24 February 2015

RE: MP10_0165 MOD1 – 5 Whiteside Street & 14-16 David Avenue, North Ryde

CLIENT SKYLAKE GROUP PTY. LTD. LEVEL 39, 264 GEORGE STREET SYDNEY NSW 2000	DRAWING TITLE LEVEL TWO - FLOOR PLAN			
PROJECT WHITESIDE STREET, NORTH RYDE	SCALE 1:250 @ A1 1:500 @ A3	DATE 30/10/2014	DRAWN LP	CHECKED SZ
JOB 14010	DRAWING DA-1.04			REVISION B

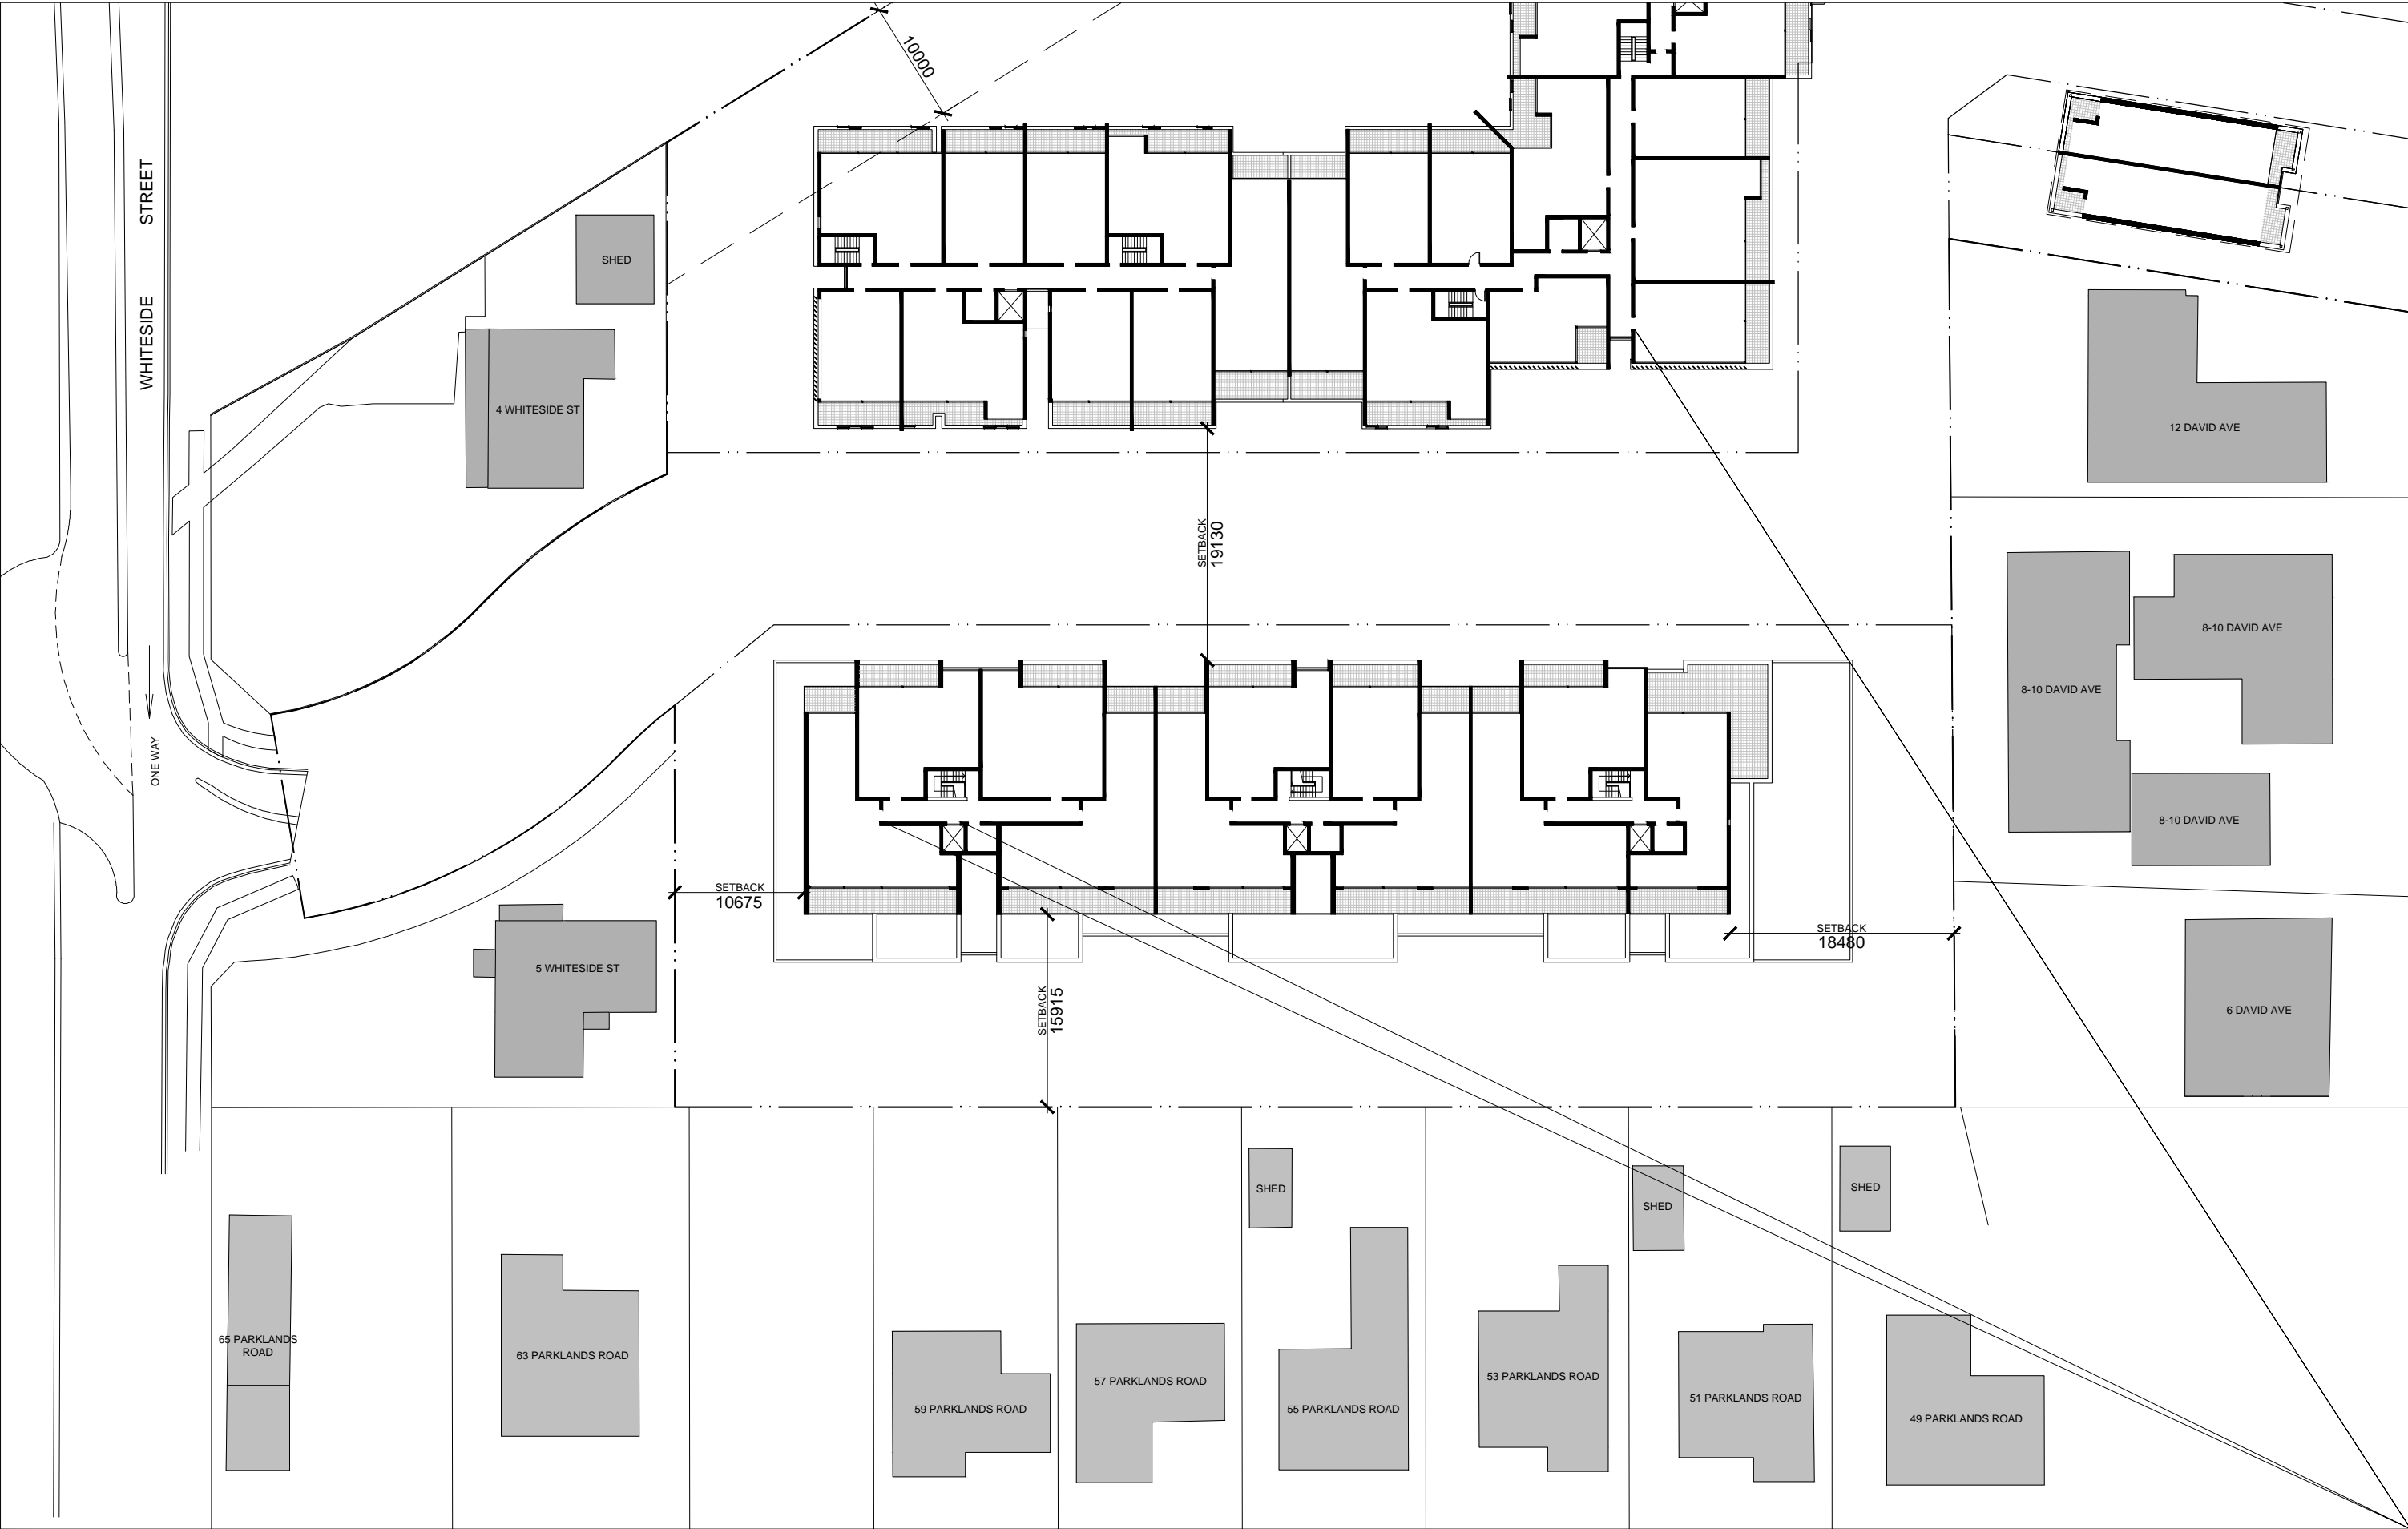
In response to concerns regarding privacy and potential overlooking from the proposed balconies on Level 2 of Building B, we provide the following comments:

- As part of the proposed modifications, the built form has been setback an additional 4.59m from that approved, improve the privacy of adjacent dwellings, compared to that approved.

- The proposed balconies are over 15.9m from the south western boundary of the site. This setback exceeds the proposed building separation controls planned in the Department of Planning and Environment's Draft Apartment Design Guidelines (ADG):

- The Draft ADG control for building separation states for buildings up to four storeys 12m is to be provided between habitable rooms/balconies, and where the site is at the boundary between a change in zone from apartments to a lower density zone, the building setback is to be increased by 3m (i.e. a total setback of 15m).

- Whilst this control does not strictly apply to this development, the proposed setback between the balconies and the rear boundary of the site complies with this numeric guideline.

For clarity, the proponent commits to ensuring that no balconies are proposed immediately opposite the properties at 8-10 David Avenue, which is consistent with the original approval. The proposed amendment will allow up to six balconies on Level 2 of Building B fronting the rear of the properties along Parklands Road.

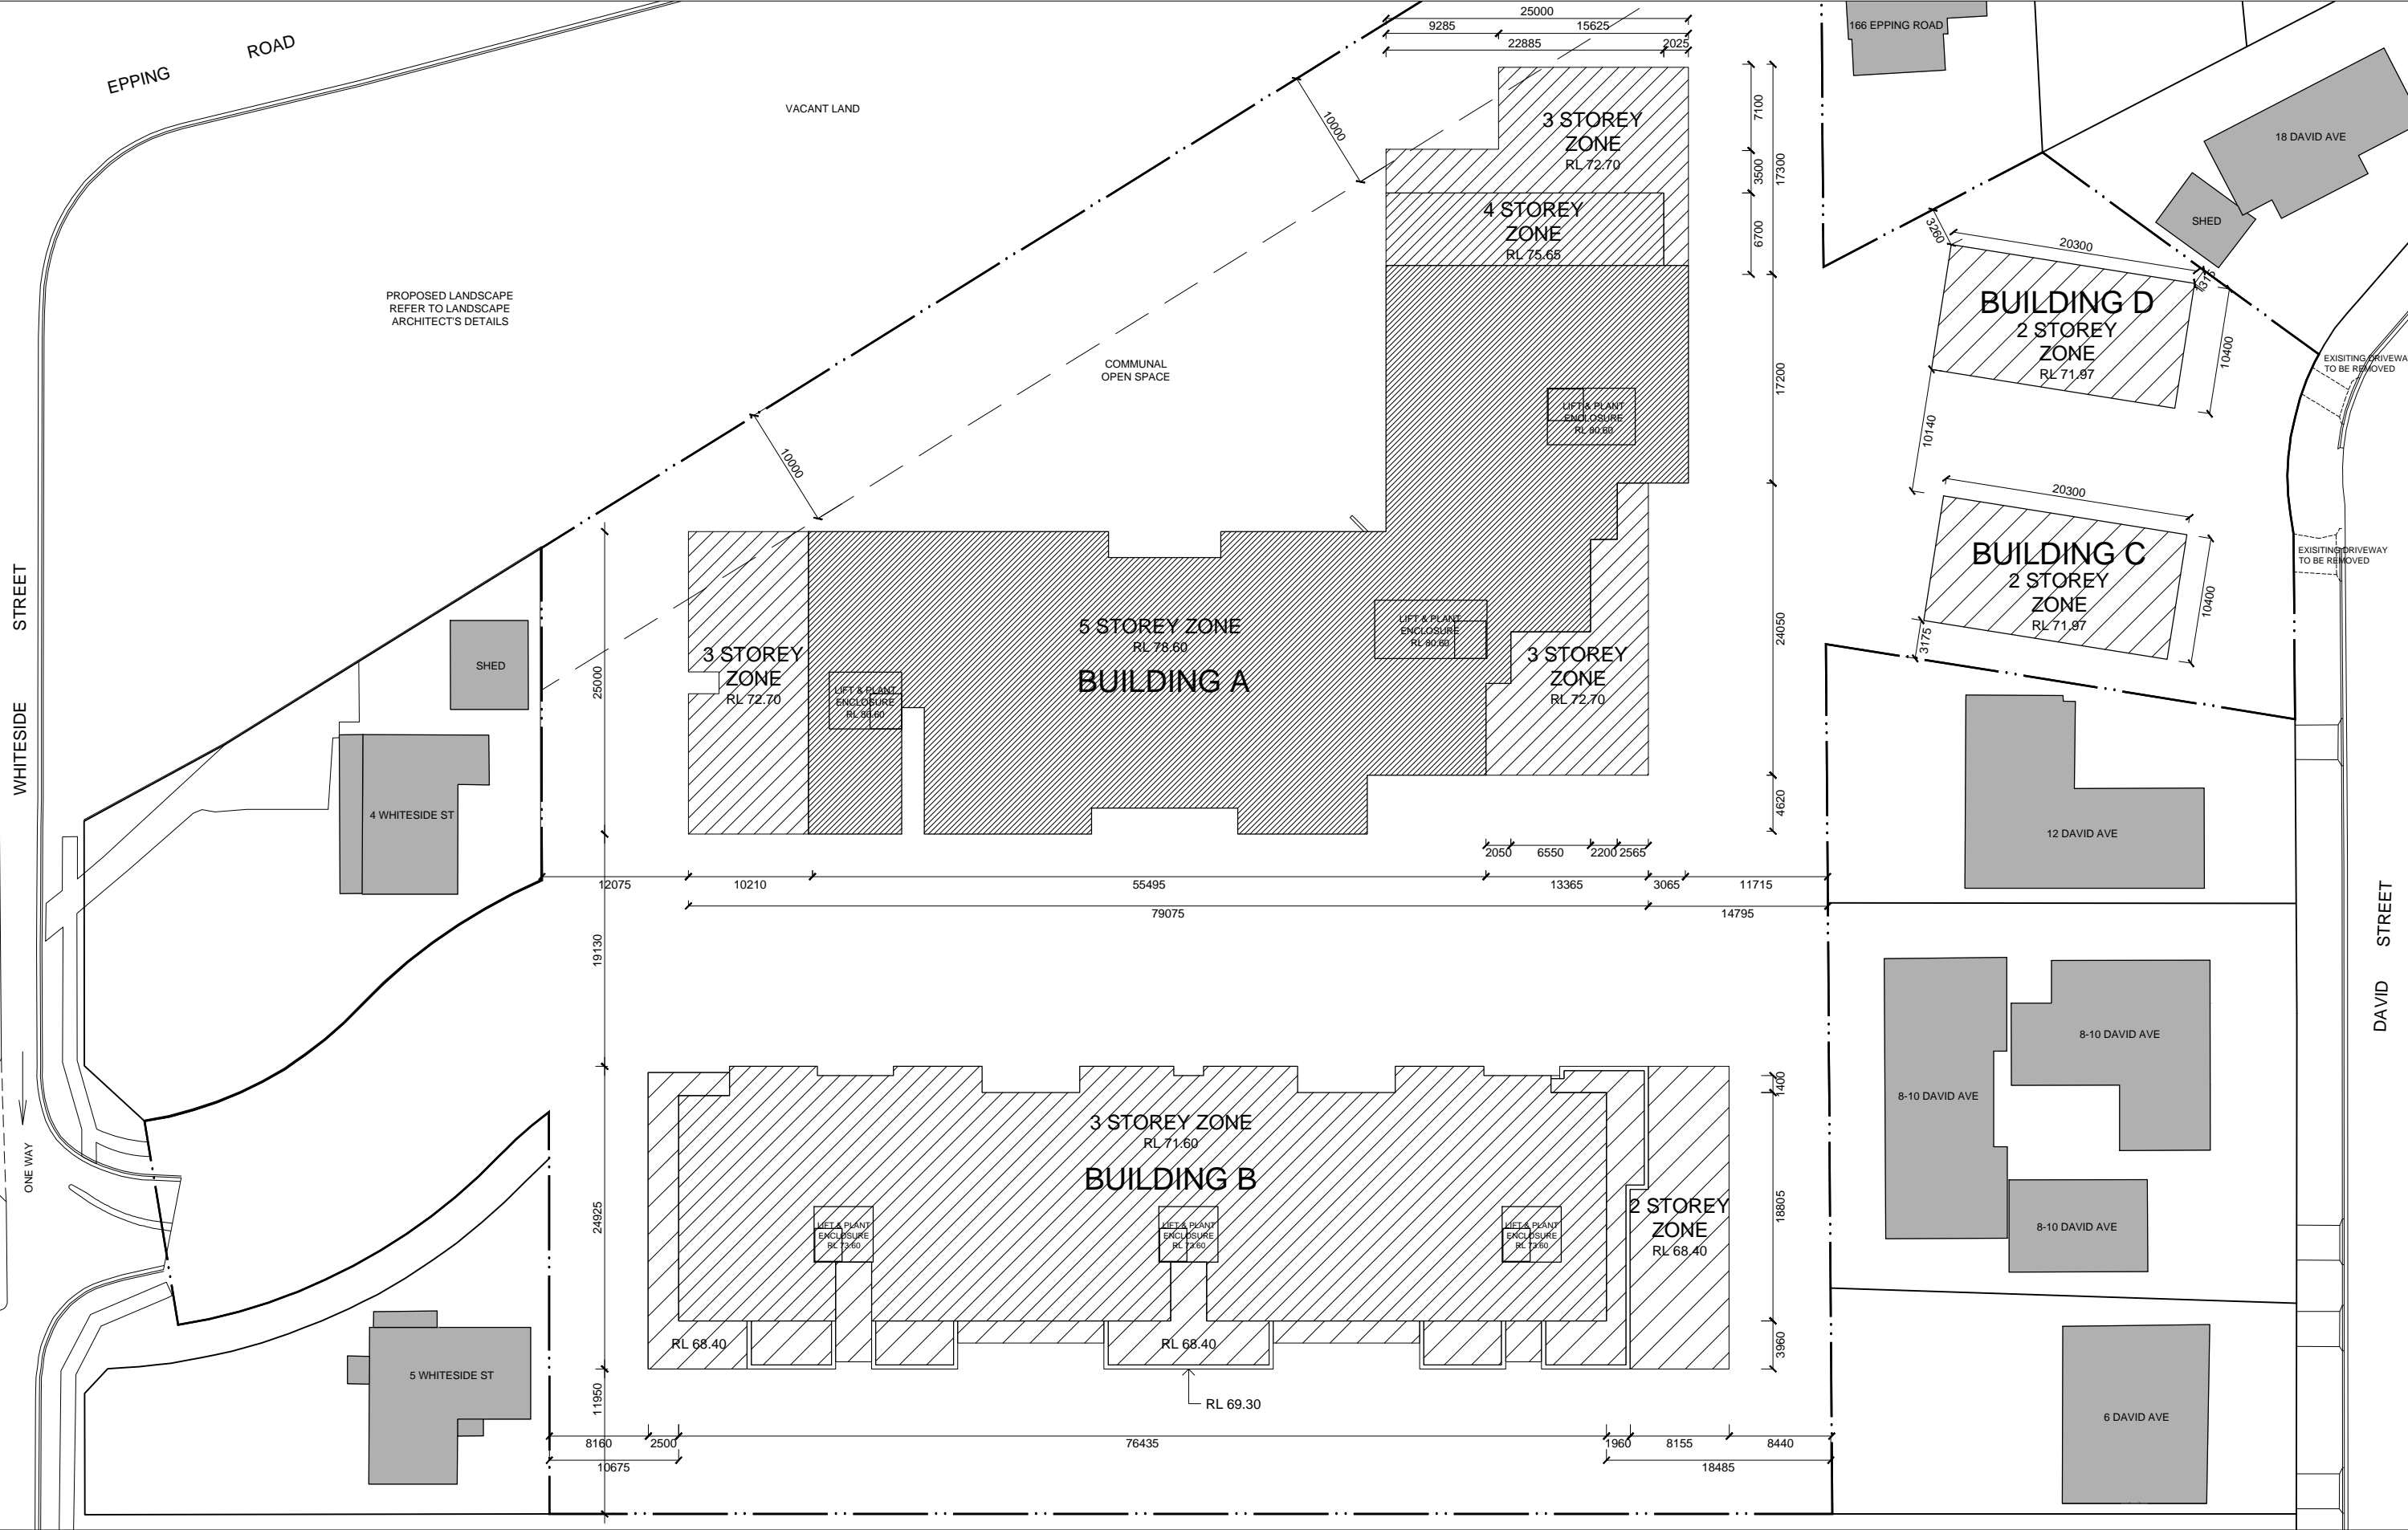
- As shown on the Landscape Plans submitted with the application, substantial deep soil planting including screen planting with the capability of growing to 15m (mature height of the Weeping Lily

Pilly, as per the indicative plant schedule), will be provided within the proposed setback zone. As shown in the indicative Section attached, even at only 8m in height this provides ample obstruction to the potential view lines at Level 2 and the rear open space of the adjacent properties.

- The proposed modification to Condition B6 includes a requirement for the proposed balustrades at this boundary to be opaque. This will further ensure that views from the internal areas are obstructed, and will further provide privacy for the occupants of the proposed units.
- The proponent confirms that the proposed balconies on Level 2 of Building A will be directly adjoining bedrooms and bathrooms only.
- The provision of balconies increases the proposed setback to the glazing line to over 17m, protecting the privacy of future occupants of the units. Further, the provision of balconies will improve the amenity of these units.
- Only six balconies are proposed on this boundary, which does not result in a significant number of 'additional eyes' at this boundary.
